P802.1ASdm/D2.5 July 8, 2024

Timing and Synchronization for Time-Sensitive Applications

Amendment: Hot Standby and Clock Drift Error Reduction

Figure 7-6—Time-aware network example for hot standby with both GM and partial path redundancy

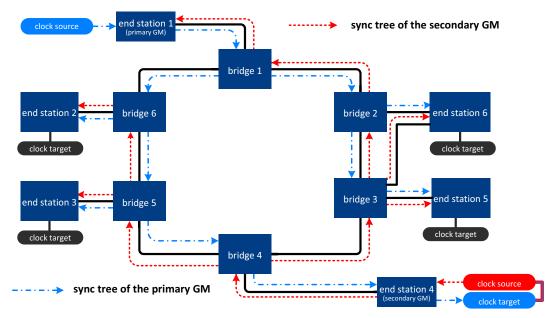
Add the following new subclause after 7.2.4, and renumber figures as necessary:

Figure 7-6 shows an example of a time-aware network with hot standby (see Clause 18). The network has GM redundancy and path redundancy to all the bridges and end stations 1, 4, and 6 (path redundancy for end stations 2, 3, and 5 is possible, but is not illustrated to avoid clutter in the figure). In addition, for simplicity the optional split functionality (see 18.5.3.4) is assumed to be disabled.

Figure 10-2—Time-synchronization state machines—overview and interrelationships

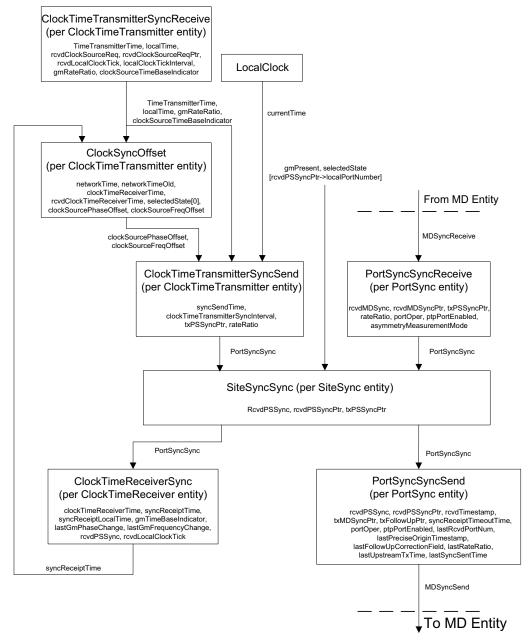
Change 10.2.1 and Figure 10-2 as follows:

Figure 10-6—Clock Time Transmitter Sync Offset state machine

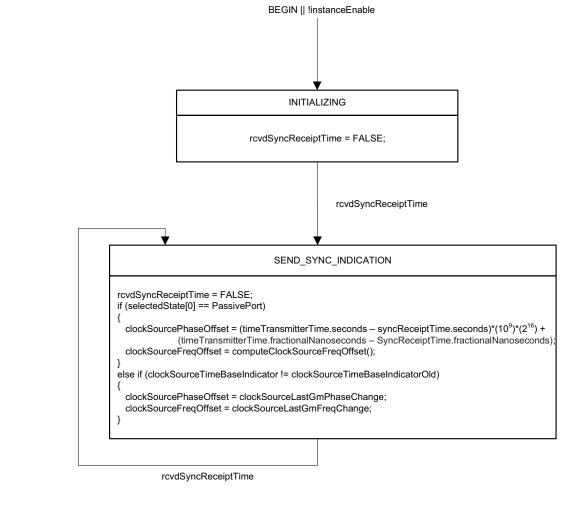
Replace Figure 10-6 with the following:

Figure 10-9—ClockTimeReceiverSync state machine

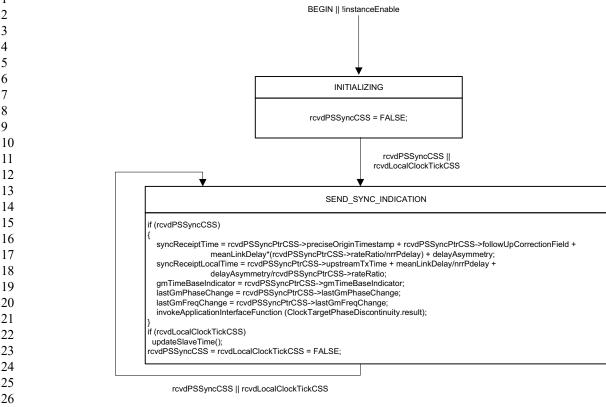
NOTE—This figure differs from the 2020 edition, with Corrigendum 1 and IEEE Std 802.1ASdr-2024 applied, of this standard in that the variable neighborRateRatio is replaced by nrrPdelay in the first two statements of the SEND SYNC INDICATION block.

Figure 10-12—External port configuration state machines—overview and interrelationships

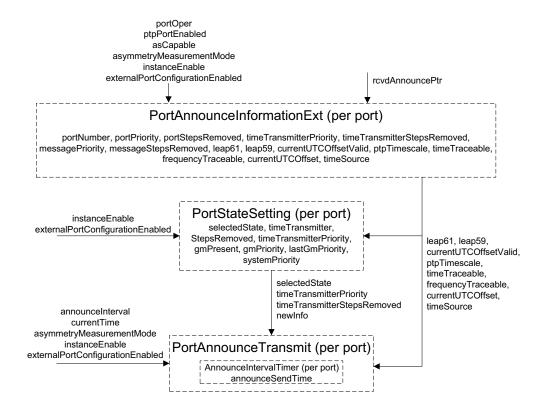
Replace Figure 10-12 with the following:

NOTE—This figure differs from the 2020 edition, with Corrigendum 1 and P802.1ASdr IEEE Std 802.1ASdr-2024 applied, of this standard in that the variable newInfo is removed from the link between the PortAnnounceInformationExt and PortAnnounceTransmit blocks and added to the link between the PortStateSetting and PortAnnounceTransmit blocks.

Figure 10-16—PortAnnounceInformationExt state machine

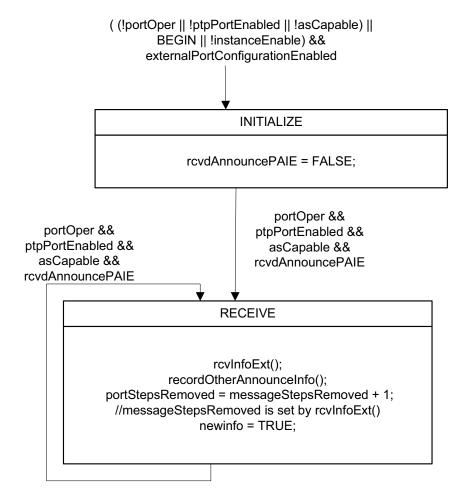
Change 10.3.14.3 as follows:

NOTE—This figure differs from the 2020 edition, with Corrigendum 1 and P802.1ASdr IEEE Std 802.1ASdr-2024 applied, of this standard in that the statement newinfo = TRUE; is added after the existing statements in the RECEIVE state.

Figure 10-18—PortAnnounceTransmit state machine

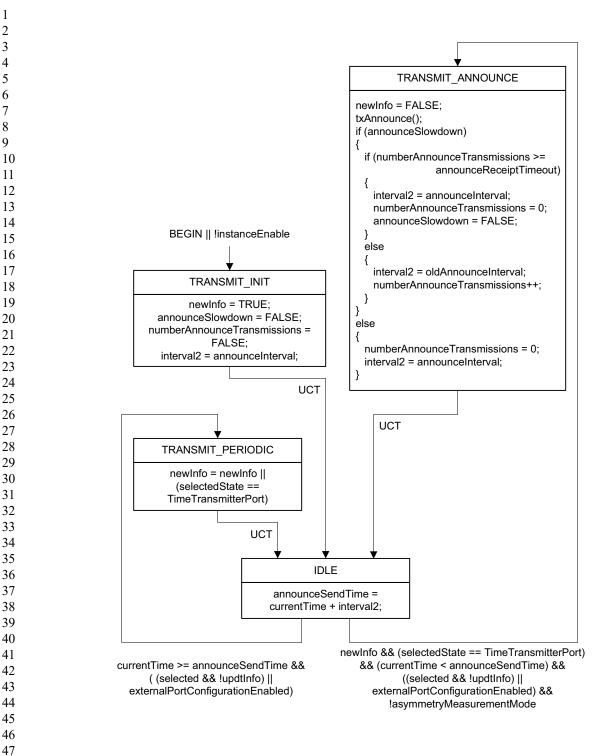
Replace Figure 10-18 with the following:

NOTE 2—This figure differs from the 2020 edition, with Corrigendum 1 and P802.1ASdr IEEE Std 802.1ASdr-2024 applied, of this standard in that the statement interval 2 = announceInterval is added after the existing statements in the TRANSMIT INIT state.

Figure 11-6—MDSyncReceiveSM state machine

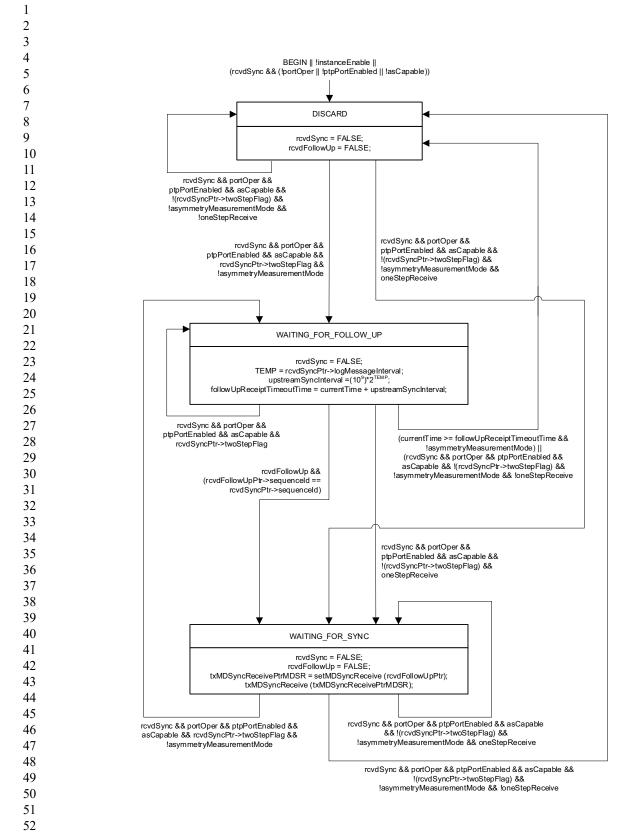
Replace Figure 11-6 with the following:

NOTE—This figure differs from the 2020 edition, with Corrigendum 1 applied, of this standard in that the variable portEnabledOper at the entry to the DISCARD state is changed to portOper.

Figure 11-7—MDSyncSendSM state machine

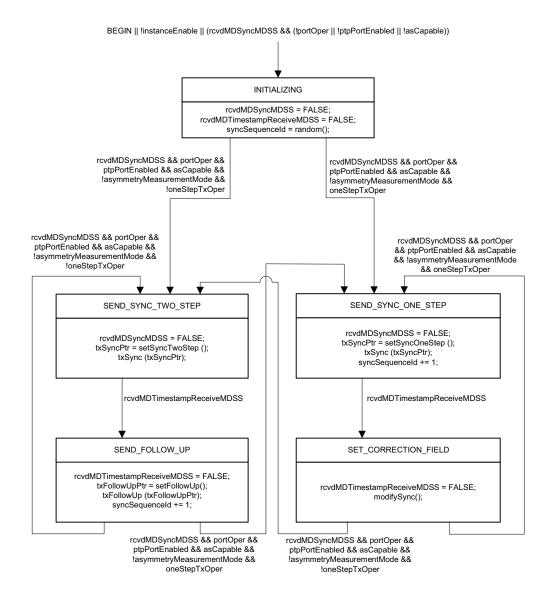
Replace Figure 11-7 with the following:

NOTE—This figure differs from the 2020 edition, with Corrigendum 1 applied, of this standard in that (a) the variable portEnabledOper is changed to portOper on the links between the SEND_FOLLOW_UP and SEND_SYNC_TWO_STEP states, between the SEND_FOLLOW_UP and SEND_SYNC_ONE_STEP states, and between the SET_CORRECTION_FIELD and SEND_SYNC_TWO_STEP states; and (b) the statement 'syncSequenceId += ' in the last line of the SEND_SYNC_TWO_STEP state is moved to the last line of the SEND_FOLLOW UP state.

Figure 11-9—MDPdelayReq state machine

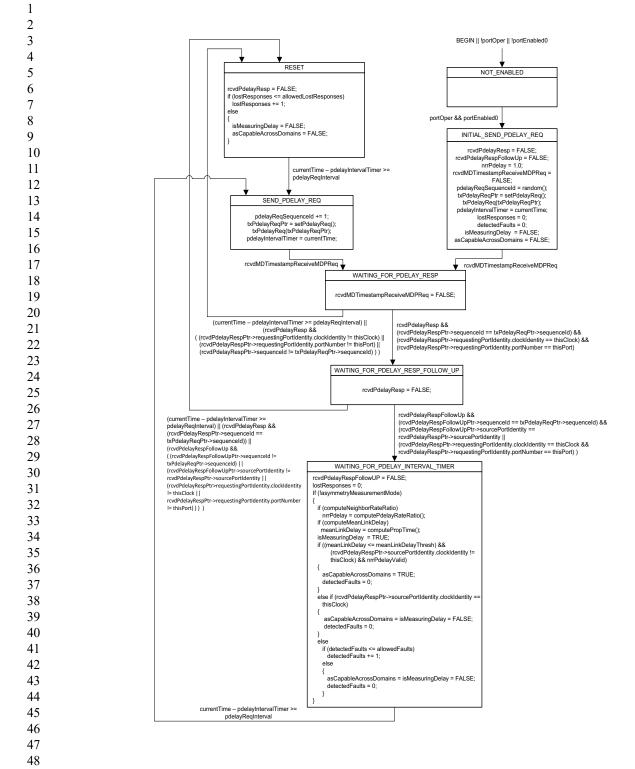
Replace Figure 11-9 with the following:

NOTE—This figure differs from the 2020 edition, with Corrigendum 1 applied, of this standard in that (a) the condition "else if (rcvdPdelayRespPtr->sourcePortIdentity.clockIdentity != thisClock)" in the state WAITING_FOR_PDELAY_INTERVAL_TIMER is changed to "else if (rcvdPdelayRespPtr->sourcePortIdentity.clockIdentity == thisClock)" (i.e., "!=" is changed to "=="), and (b) the variables neighborRateRatio and neighborRateRatioValid are replaced by nrrPdelay and nrrPdelayValid, respectively.

Figure 17-1—Overview of YANG tree

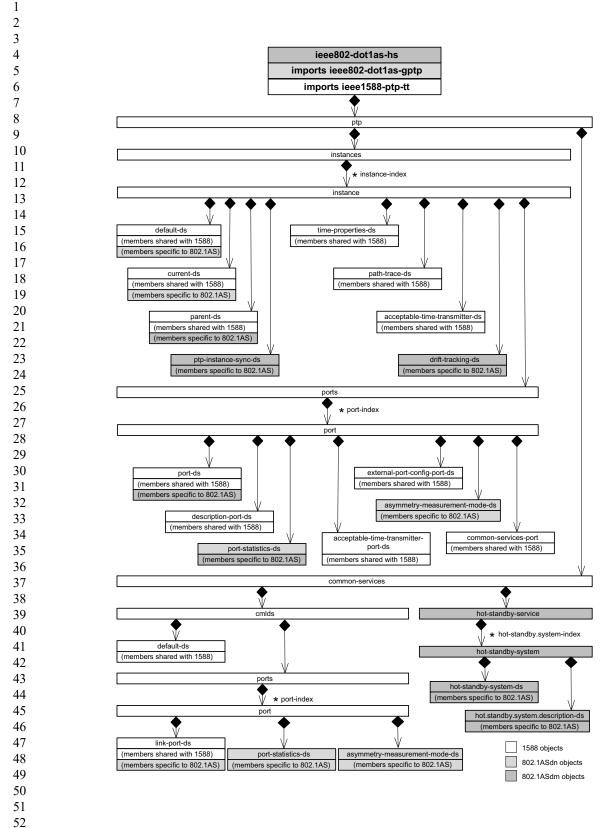
Replace Figure 17-1 with the following:

NOTE 1—This figure differs from the 2020 edition of this standard with Corrigendum 1 applied and as amended by IEEE Std 802.1ASdn in that managed objects needed for the hot standby and Drift_Tracking TLV features are added.

Figure 17-2—PTP Instance detail

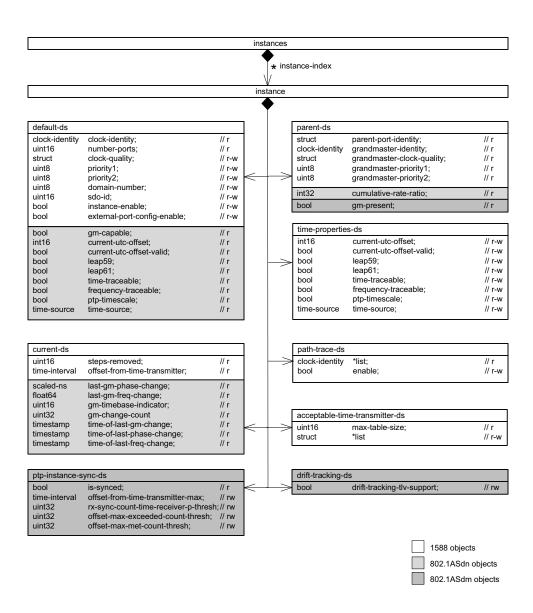
Replace Figure 17-2 with the following:

NOTE 2—This figure differs from the 2020 edition of this standard with Corrigendum 1 applied and as amended by IEEE Std 802.1ASdn in that managed objects needed for the hot standby and Drift_Tracking TLV features are added.

Figure 17-3—PTP Port detail

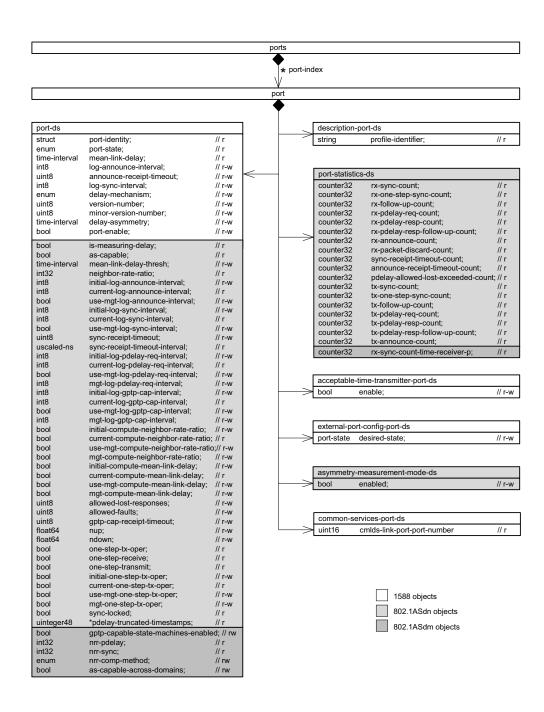
Replace Figure 17-3 with the following:

NOTE 3—This figure differs from the 2020 edition of this standard with Corrigendum 1 applied and as amended by IEEE Std 802.1ASdn in that managed objects needed for the hot standby and Drift_Tracking TLV features are added.

Figure 17-4—Common services detail

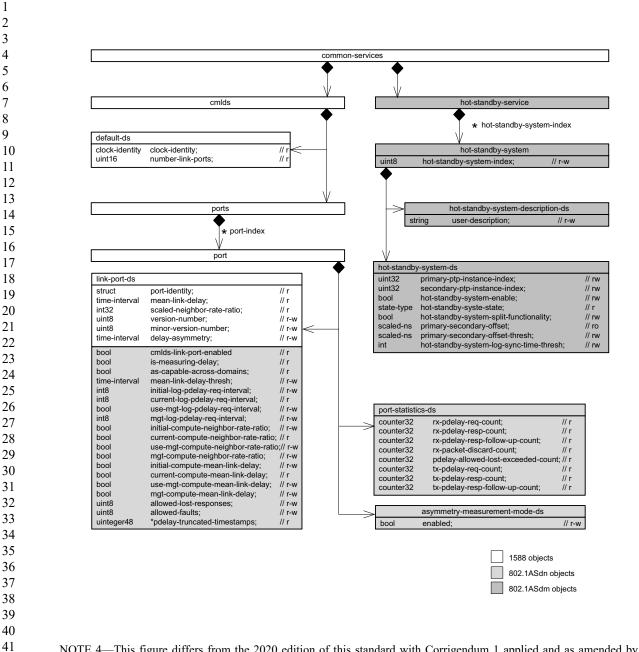
Replace Figure 17-4 with the following:

NOTE 4—This figure differs from the 2020 edition of this standard with Corrigendum 1 applied and as amended by IEEE Std 802.1ASdn in that managed objects needed for the hot standby and Drift_Tracking TLV features are added.

Figure G-1—Asymmetry compensation measurement procedure

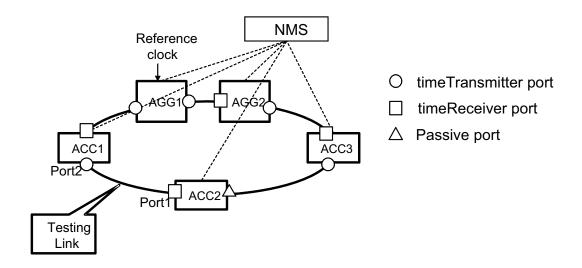
Change G.3 as follows:
